RfR Tunnelling Questions for Independent Expert (Jan 2009)

**Prepared by the Independent Engineering Expert panel for Dublin Metro North  
February 2009 (minor revisions March 31<sup>st</sup> 2009)**

**i. Crossover formed from running tunnels**

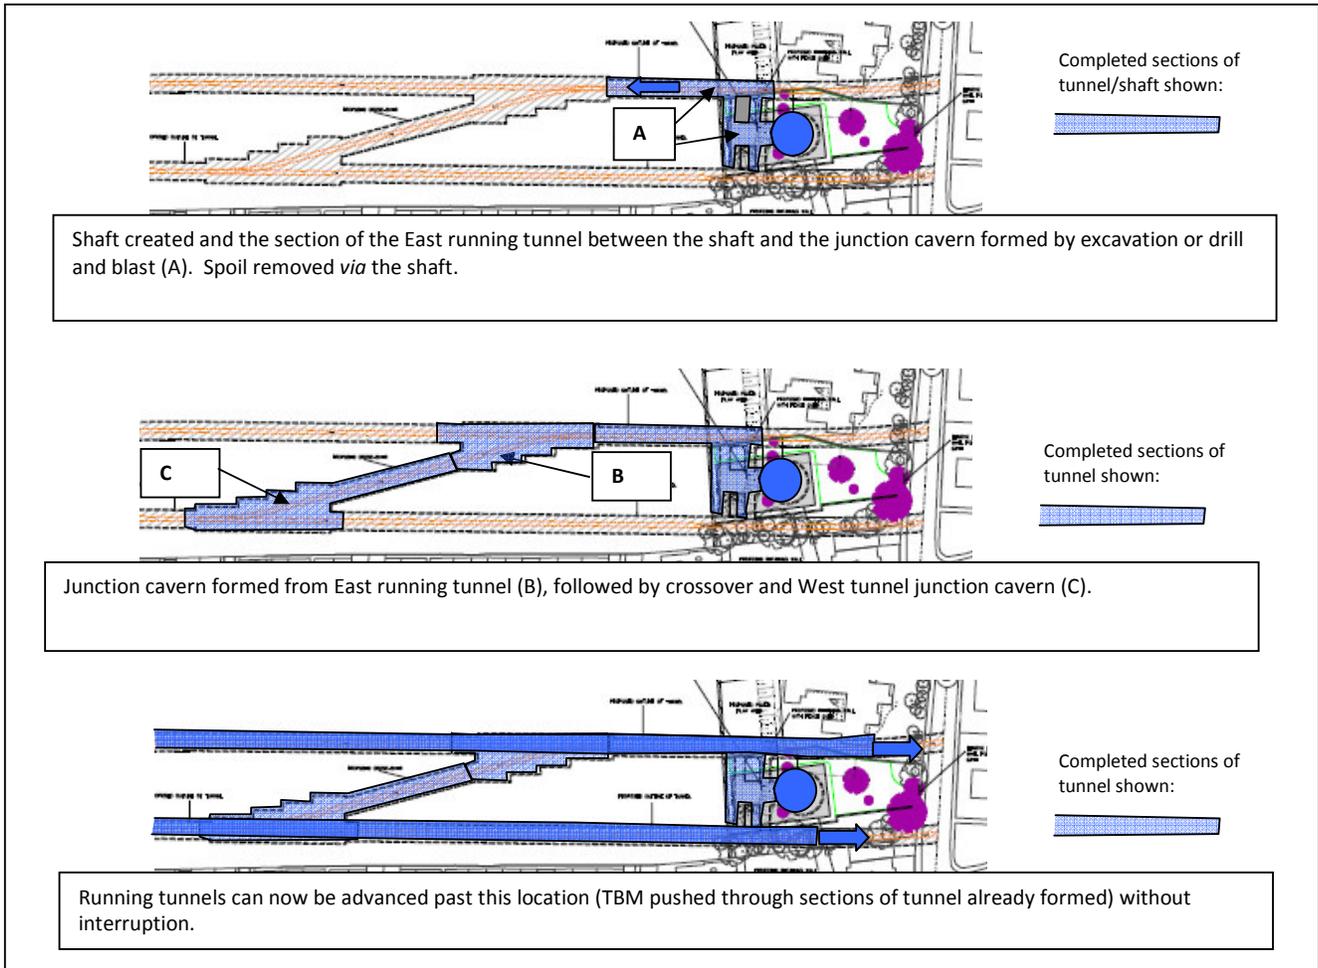
Both running tunnels (A1 and A2 above) advanced by TBM beyond the junction with the crossover tunnel. Behind each TBM is the transport and support infrastructure for the TBM (conveyor or railway for spoil out and materials in, electricity, hydraulics etc)

Running tunnel linings need to be removed and then the tunnel at the junctions (B1 and B2) will be widened out. Whilst this is done, the TBM operation will be interrupted because it will not be possible to maintain the transport and support infrastructure past the junction works. The construction of each junction would disrupt the progress of the TBM in that tunnel whilst the work is completed (either the TBM would stop in the affected running tunnel for the duration of the works on the junction or there would be frequent interruptions to its progress). Spoil from the junction caverns would be removed via completed sections of running tunnels.

Once each junction cavern is complete, the TBM infrastructure can be re-established and boring of the running tunnels can resume without further interruption. The crossover itself (C) can be completed between the junction caverns whilst the TBM is operating (from one end or the other or in both directions alternately or simultaneously).

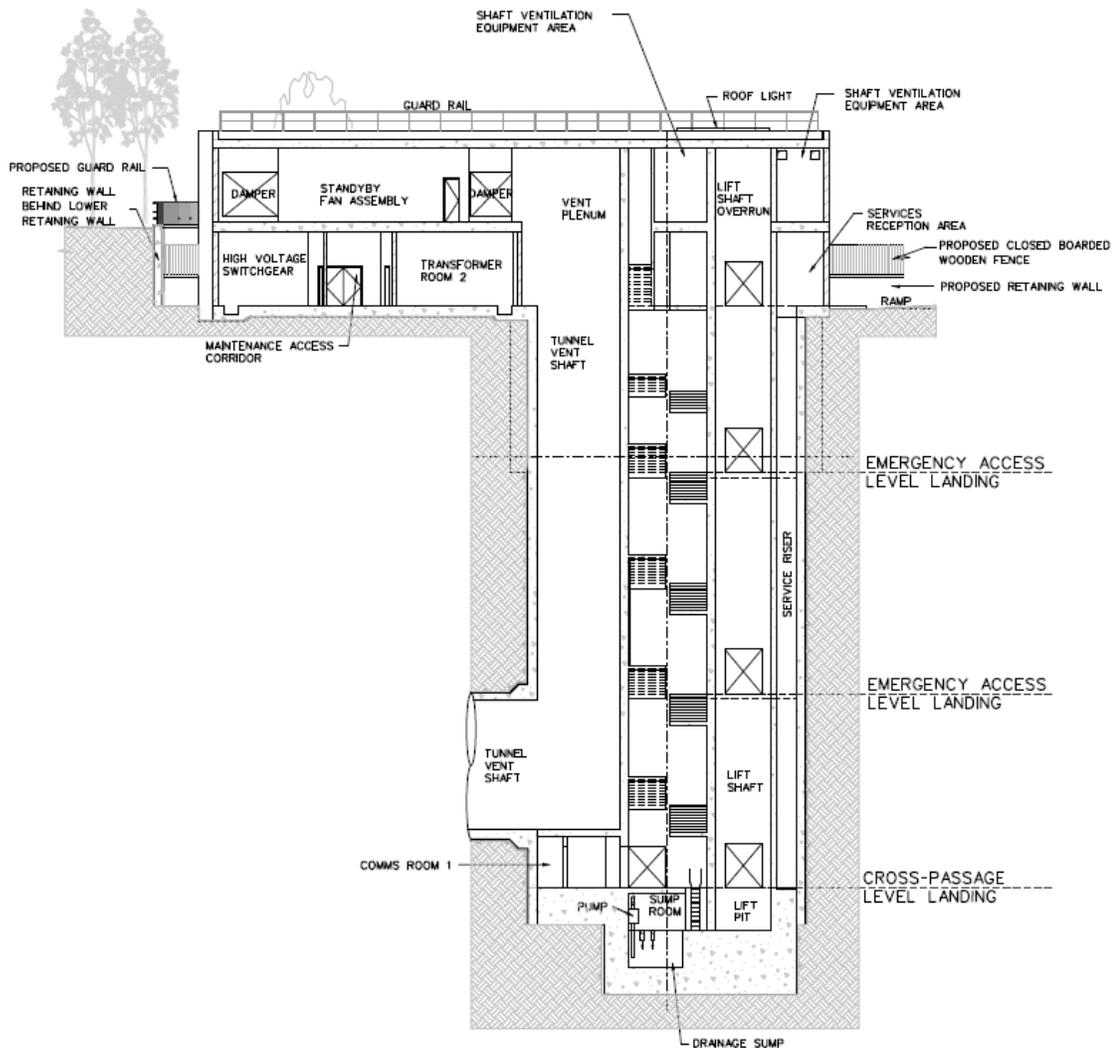
The alignment runs from Griffith Avenue to Drumcondra in bored tunnels. As the length of the bored section of tunnel between Griffith Avenue and Drumcondra stations exceeds 1km, an emergency access and ventilation shaft is required for fire safety and for operational reasons, approximately at the midpoint of the section<sup>[EIS, V1, Ch5, p63 & Ch6, p78]</sup>. The positioning of this shaft in relation to the surface and the running tunnels is the most expeditious; it is approximately midway between the two stations and is between the two running tunnels. Its location in relation to the tunnels ensures that the underground route for emergency egress from either tunnel is as short as possible. Similarly, its proximity to the tunnels (by being between them) reduces to a minimum the length of additional tunnels that will be required for the purposes of ventilation. Its surface location is in the corner of a sports pitch. Whilst the site access is onto rather narrow residential streets, emergency vehicles and personnel would be able to gain access to it *via* St Patrick's College. This surface location would ensure that those evacuated from the tunnels in an emergency would emerge into an open space and not spill onto the streets.

A shaft offset from the tunnel line (*e.g.* to facilitate access for emergency vehicles from larger roads or to move the shaft building and ventilation fans further away from buildings) would require the construction of additional ventilation/draught relief tunnels, thereby increasing the cost of the project. It is probable that operational costs would also be higher due to a requirement for higher power ratings for ventilation fans (and there may be implications for meeting thresholds in relation to airborne noise levels).

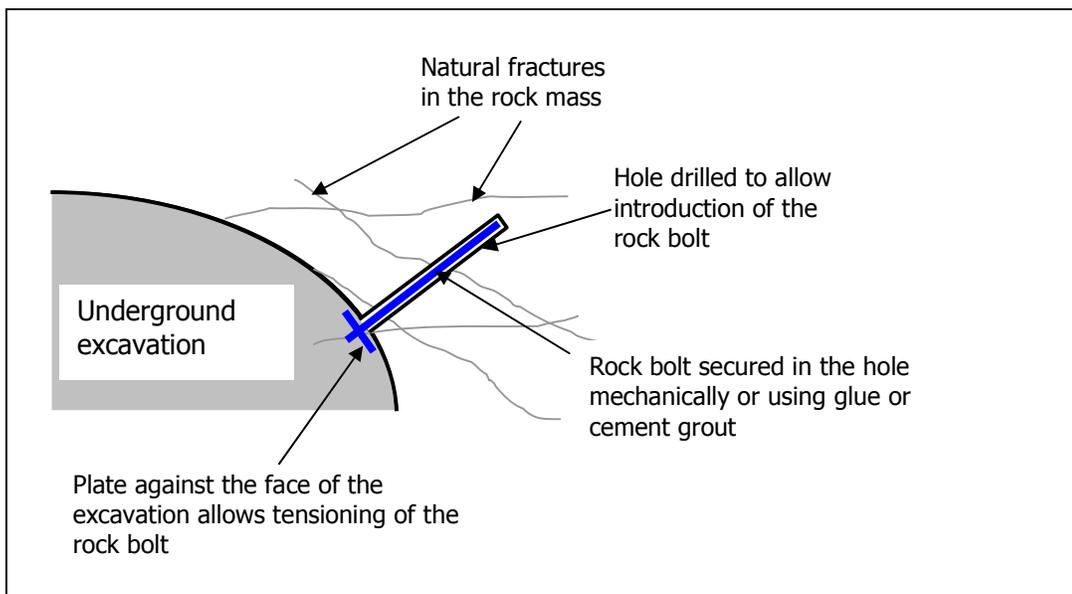
Thus when the TBMs enter a station box they will be propelled forward through the box by thrusting against invert segments (the lowest segment of the segmental tunnel lining) only. It would be unusual to have to convert this efficient system into one that pulls. It can be confidently anticipated that this operation will be almost noiseless. The thrust rams are powered by electro-hydraulic power packs which are very low noise emitters. Of the activities that will

take place within station boxes whilst they are fully or partially open to the atmosphere, this activity will not contribute to the overall construction noise.
